The Commission has issued the enclosed Amendments Nos. 24 and 21 to Facility Licenses Nos. DPR-33 and DPR-52, respectively, for the Browns Ferry Nuclear Plant, Units Nos. 1 and 2.

BROWNS FERRY NUCLEAR PLANT UNIT NO. 1

BROWNS FERRY NUCLEAR PLANT UNIT NO. 2

ATTACHMENT TO LICENSE AMENDMENT NO. 24 TO DPR-33

Figure 4.8-1

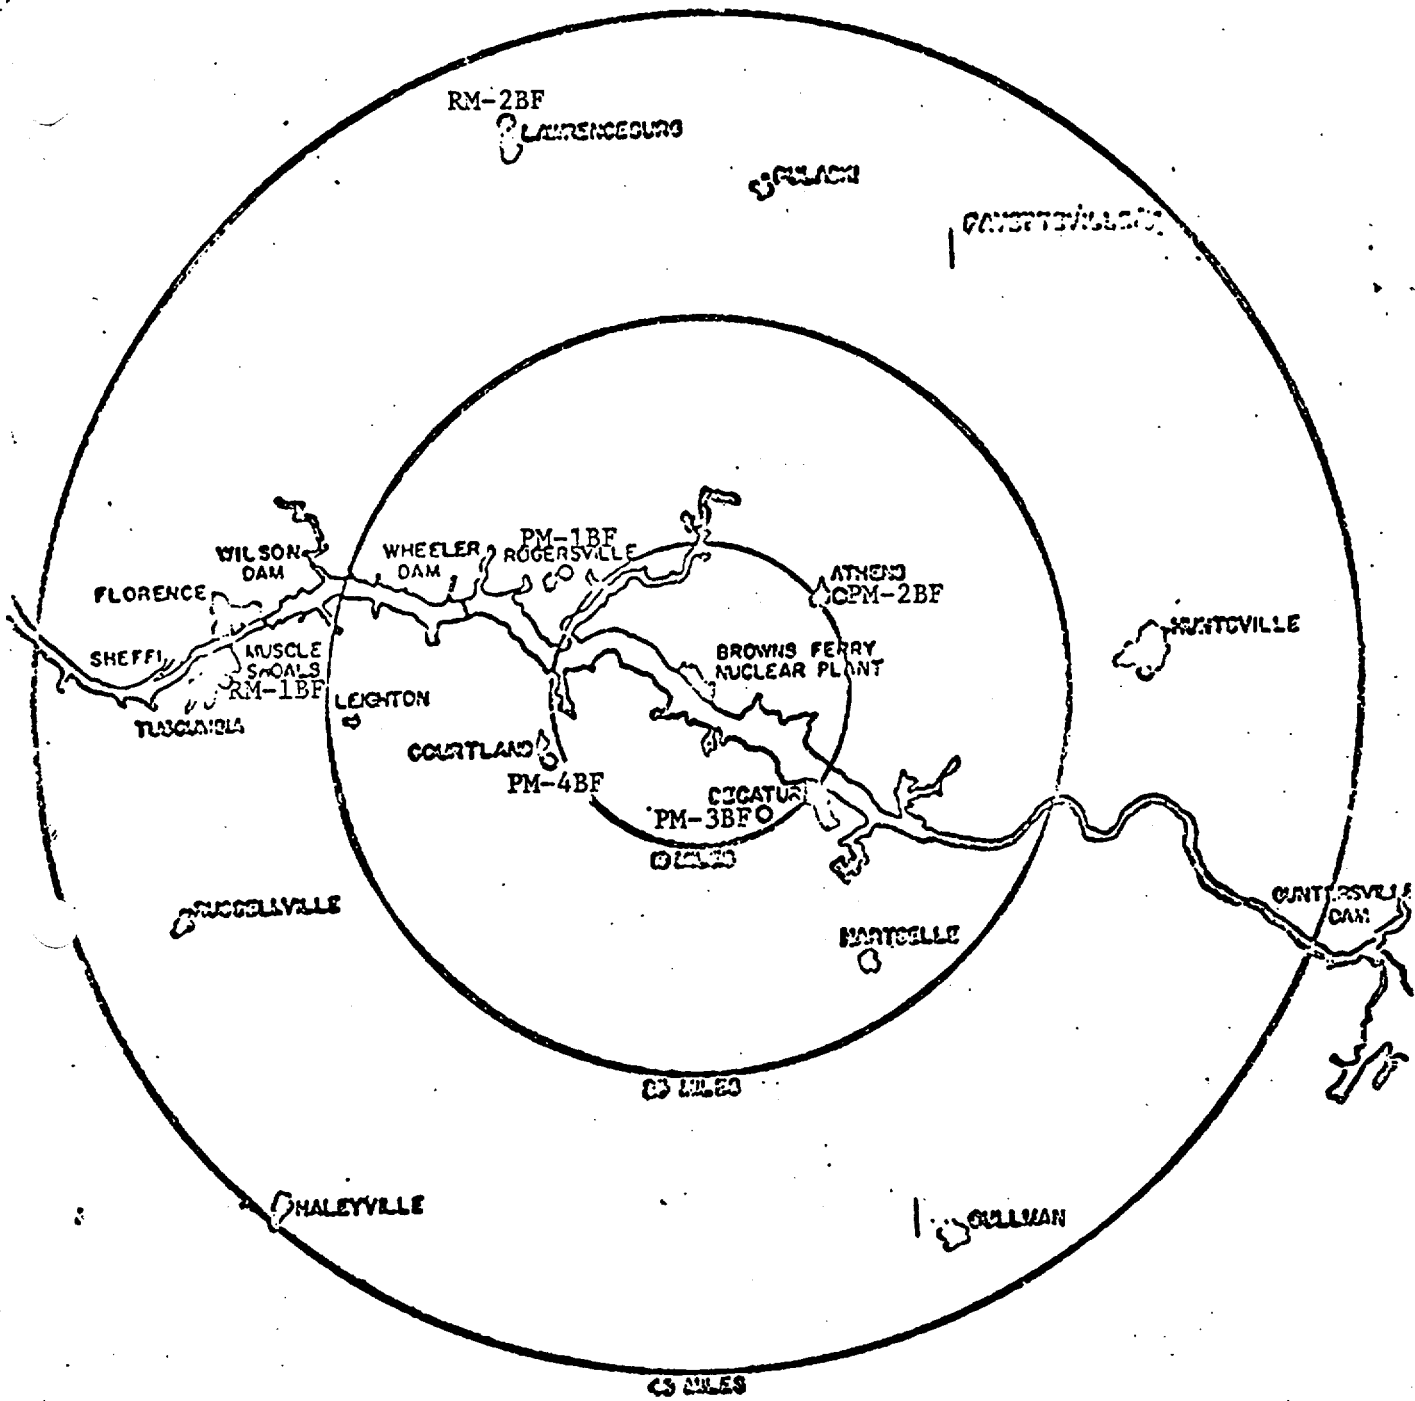
These amendments change the provisions in the Technical Specifications to revise the network of remote atmospheric monitoring stations to conform with the network as approved by the Commission for Unit No. 3. They permit the relocation of two remote air monitors from distant location, 45 miles from the facility. One of these monitors will be relocated to the site boundary of the facility, and the other will be available as a stand-by for any of the eleven remote air monitors which becomes inoperable. Monitoring at distances of about 45 miles from the plant is adequately provided by two other distant remote air monitoring stations.

- a. The atmospheric monitoring network is divided into three subgroups consisting of 11 monitoring stations. The monitoring stations are shown on Figures 4.8-1 and 4.8-1a. These monitoring locations are subject to change dependent upon continued evaluation of the environmental monitoring program. The station at Muscle Shoals will be used as background reference.
